## **IV. MASTER RESPONSES**

This section includes master responses to address comments that were raised repeatedly on the following topics. The number of the letters that commented on the topics are listed in the Comment Letter Matrix, and following each comment. Page numbers indicated throughout this Amendment refer to the Draft EIR.

## Shadow Diagrams – Summer

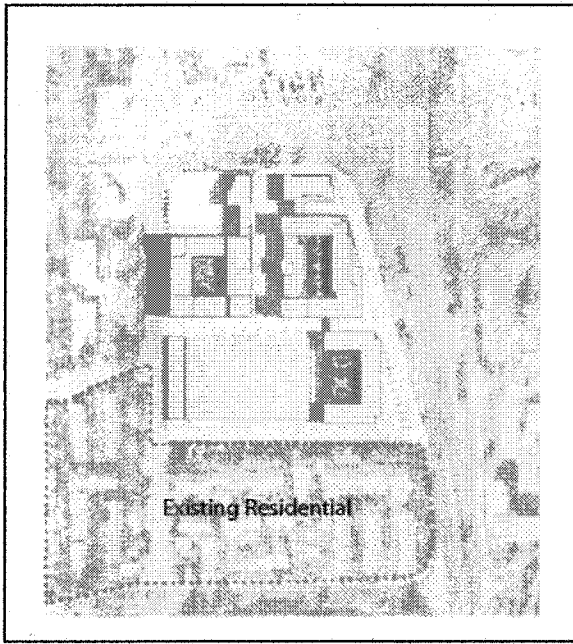
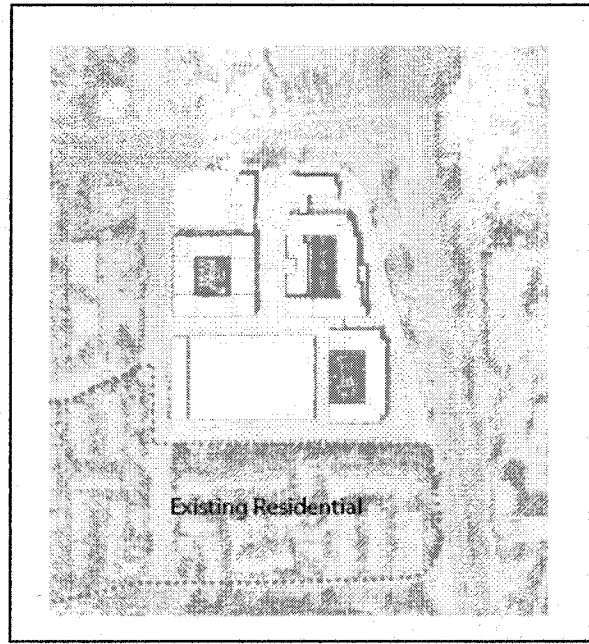
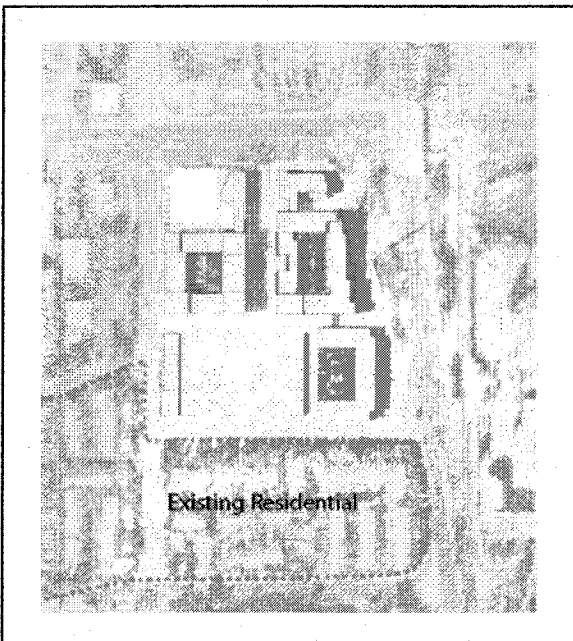
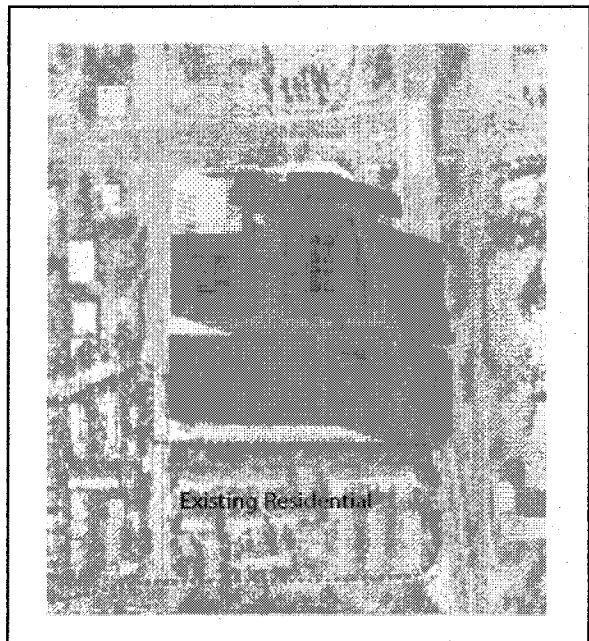
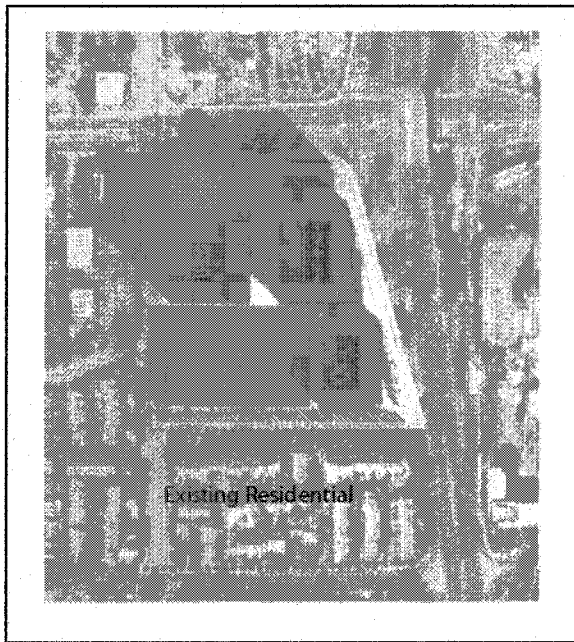
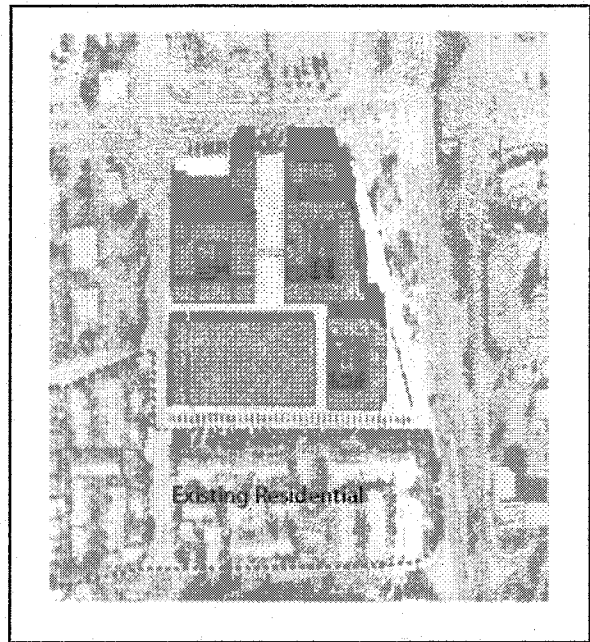
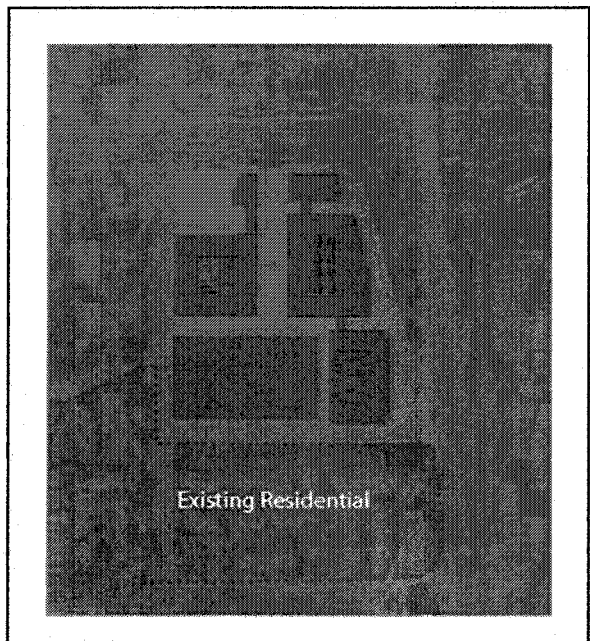
### **1. 8-story structures will block views / light** (2, 3, 7, 11, 14, 20, 29, 46, 53, 58)

Distant views from the existing residences will change; however, they are already partially blocked by trees, and more trees will be added. The view to the hills surrounding the Valley would be blocked by any development of one-story or greater along Halford Avenue; the development of the eight-story building would not increase the impact to views over that of any other building height. The project will not have a substantial adverse effect on a public scenic vista.

The proposed buildings are located north of existing residential units and, as shown on the following Shadow Diagrams, shadows from the buildings would never shade the adjacent residential area and would not block light to the units. The proposed buildings would be visible from the second-floor levels of the existing residential units, although the views would be fully or partially screened by the existing and proposed trees, as shown in the following photographs. Additional trees are proposed to fill in the empty spaces. The proximity of a mature tree screen will affect extended views to a similar degree as multi-story structures.

## Southerly Boundary

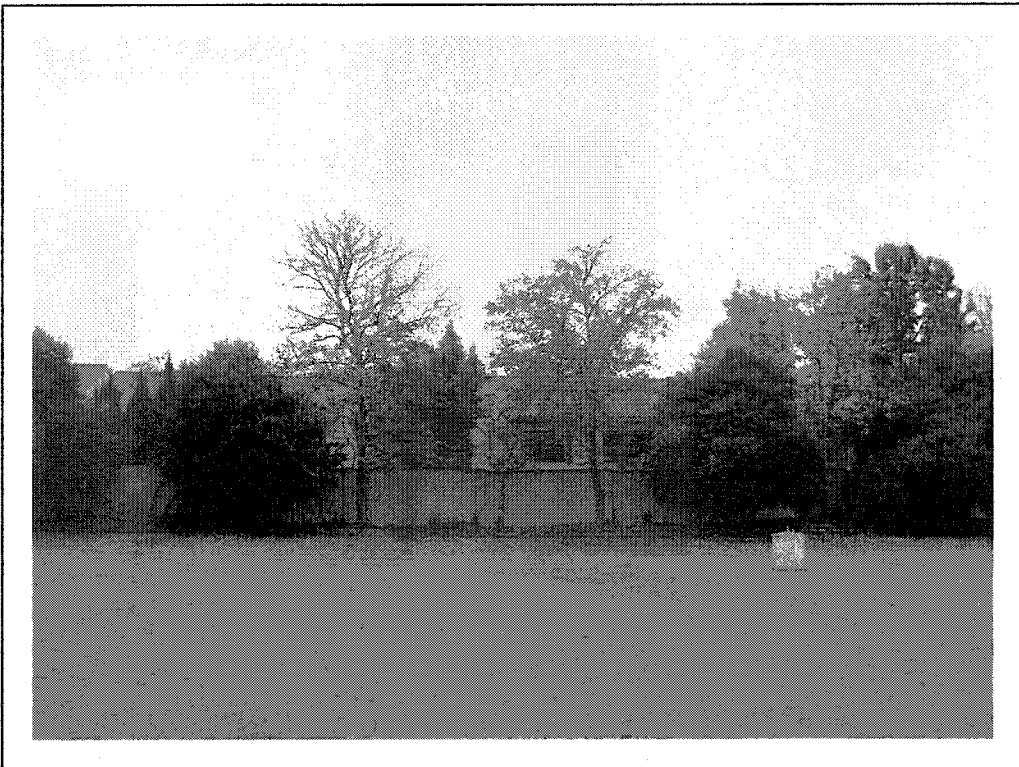
### **3. 8-story structures are incompatible with the neighborhood and with the City, and the project is too cramped and crowded** (2, 4, 6, 7, 8, 9, 12, 13, 14, 15, 16, 17, 18, 31, 34, 35, 37, 40, 41, 42, 43, 44, 45, 48, 56)

it is presumed that the restrictions would not be greater, i.e., less than 50 feet. The proposed project is located 53 feet from the nearest residential properties in the Casa del Valle development to the south, and there is a total of 83 feet between the existing residential buildings and the Santa Clara Square buildings, as proposed. In addition, the proposed project is screened by a row of existing and proposed trees along the southerly residential property line.

# Existing Townhomes Cross-Section

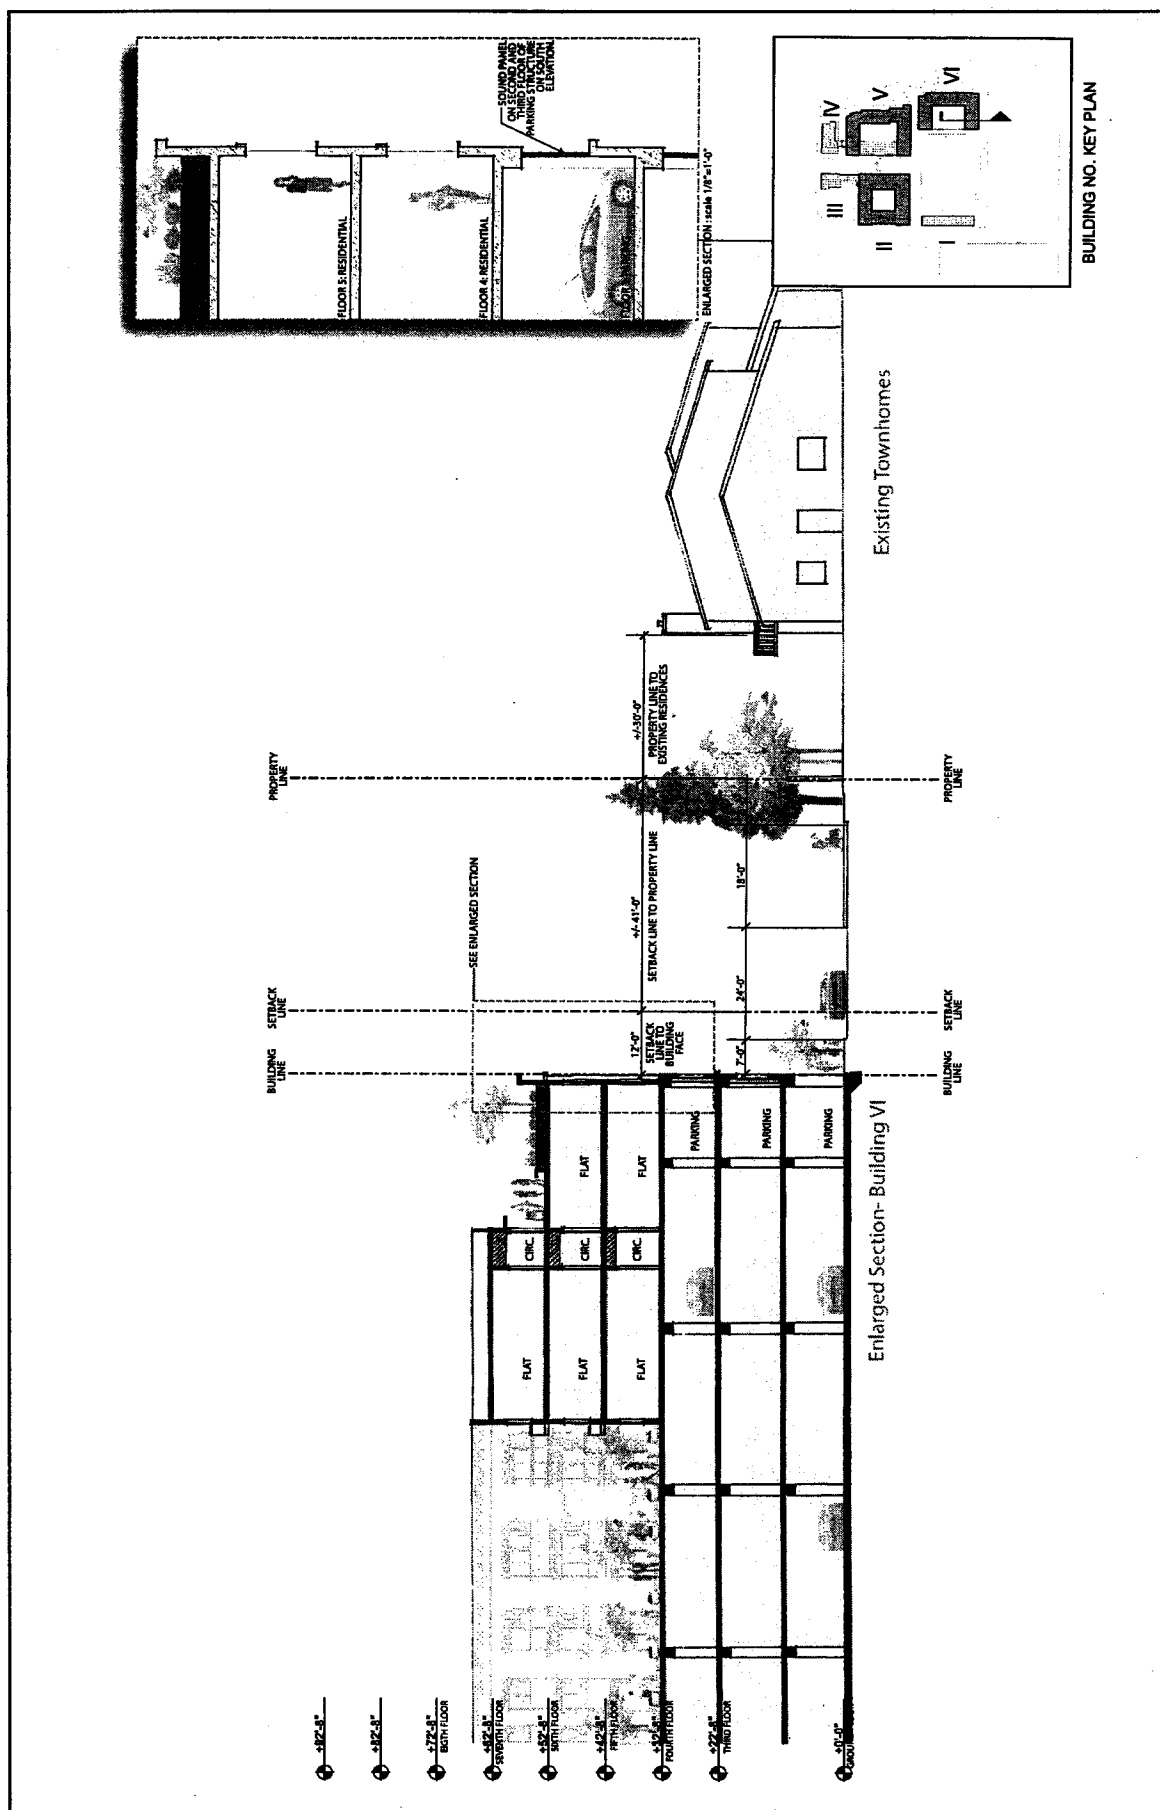
**2. Privacy will decrease** (5, 12, 13, 14, 15, 18, 20, 29, 37, 40)

Views from the residential units in Building VI will be able to look down toward the residential area to the south, but the views will be fully or partially screened by the row of 20- to 40-foot-tall trees along the property line. Building VI has also been redesigned to remove the units on the top floor that could look down into the adjacent properties in order to provide visual protection for those properties. The new terrace will prevent residents from looking down into the adjacent properties.
